ADDENDUM 2 – JOB 6

TO: All prospective bidders on project TEO-0017(015), Job No. 6 scheduled for the November 14, 2014 bid opening.

ADDENDUM 2 JOB 6

Project: TEO-0017(015) (PCN-20377)

REVISED 11/05/2014	STATE	PROJECT NO.	SECTION NO.	SHEET NO.
	ND	TEO-0017(015)	8	1

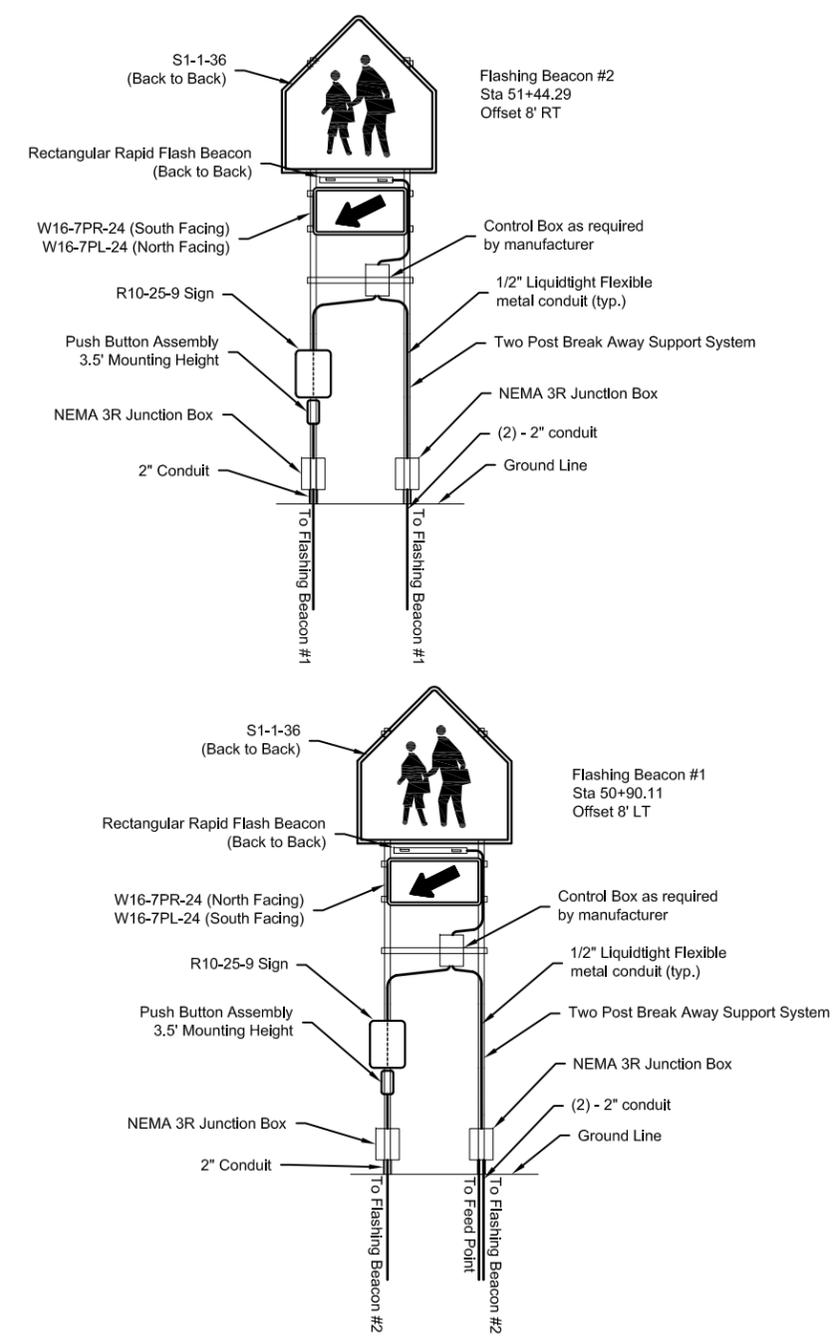
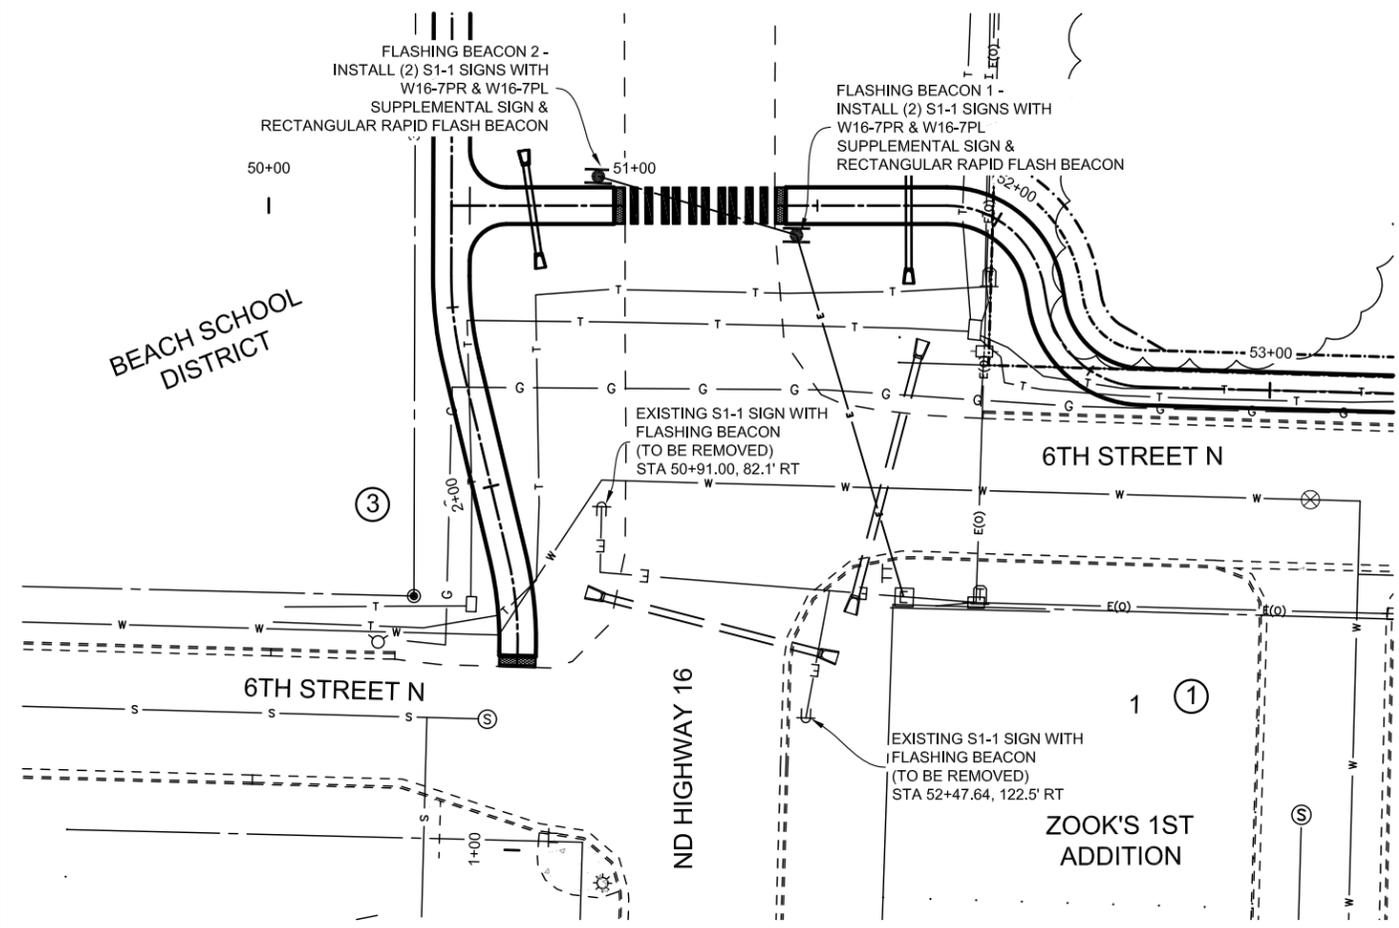
Sheet No. 8-1: "Flat Sheet for Signs-Type XI Refl Sheeting" and "Steel Galv Posts - Telescoping Perforated Tube" quantities have been revised in the Estimated Quantity table

ELECTRICAL DETAILS

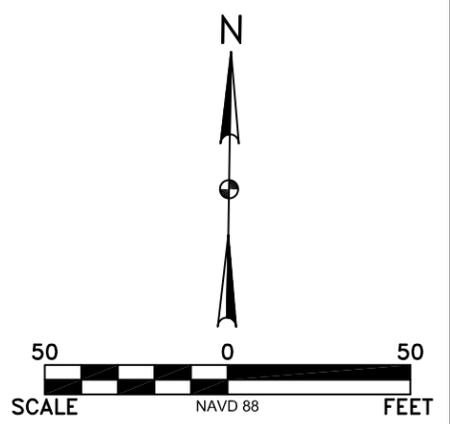
Sheet No. 150-1: Plan detail has been revised to say "Two Post Break Away support system" instead of "Post System as per manufacturer's recommendation"
